February 16, 2010  
NRC3-10-0010

Subject: Detroit Edison Company Response to NRC FSAR Request for Additional  
Information Letter No. 4 and ER Request for Additional Information  
Letter No. 2

**Response to FSAR RAI Letter No. 4 and ER RAI Letter No. 2**

**RAI Question No. 11.04-2  
RAI Question No. HH3.5-1**

Figure 11.4-1R. Solid Waste Management System Process Diagram

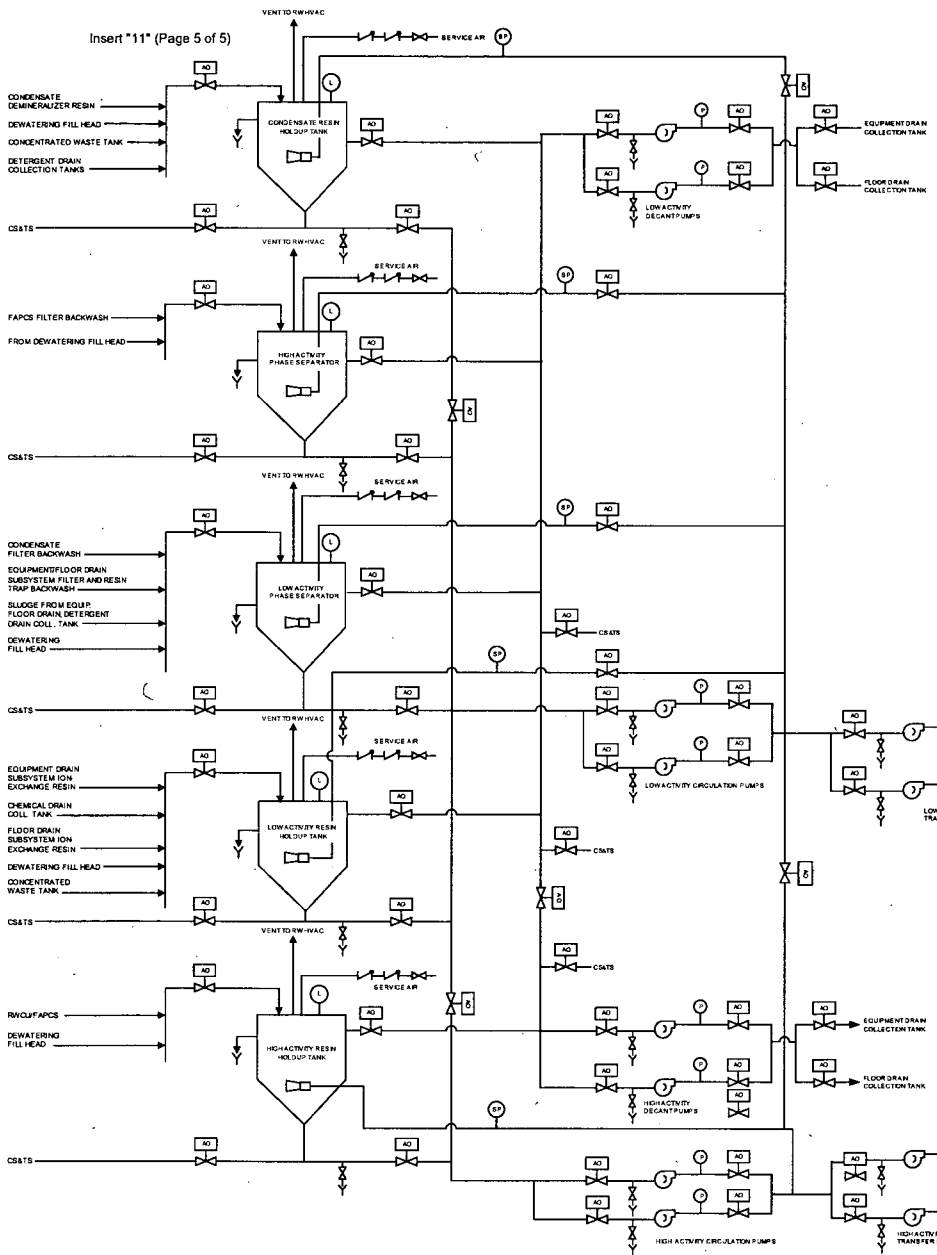
*FSAR Section 11.4.1, STD COL 11.4-4-A states that the proposed plant will not utilize temporary low-level radioactive waste storage facilities to support plant operation. The ESBWR DCD, however, provides the capacity to store the amount of low-level radioactive waste that could be generated in 6 months of operation. Accordingly, the staff requests the applicant to describe the facilities plan for long-term storage of low-level radioactive wastes projected to be generated during operation of Fermi Unit 3, and the operational program addressing the long-term management and storage of such wastes using the guidance of Regulatory Guide 1.206 and Section 11.4 of the Standard Review Plan (NUREG-0800, Rev. 3).*

*In light of the current lack of a licensed offsite disposal facility and the uncertainty regarding the availability of a new disposal facility during the license term, Detroit Edison should describe the plan for storing Class B and C LLRW onsite during the license term and the environmental consequences of such extended onsite storage. Alternatively, if Detroit Edison has a plan for managing the wastes that does not require an offsite disposal facility or extended onsite storage, it should provide details for that plan.*

See Figure 1.2-23R and Figure 11.4-1R for container storage schemes and sequencing.

HICs are provided with a passive vent equipped with a high efficiency particulate air (HEPA) filter. The HICs will vent to the general area in which they are being stored. The HICs will be provided with shield "bells". A shield bell is a steel, vertical right circular cylinder with an open bottom. It is also capable of venting to the general area. Shield bells are placed over HICs to provide radiation shielding. The Radwaste Building HVAC System is sized and designed to prevent hydrogen or biogas from accumulating in the general storage area. Furthermore, the general storage area will be monitored with hydrogen/explosive gas detectors that will alarm in the Radwaste Control Room.
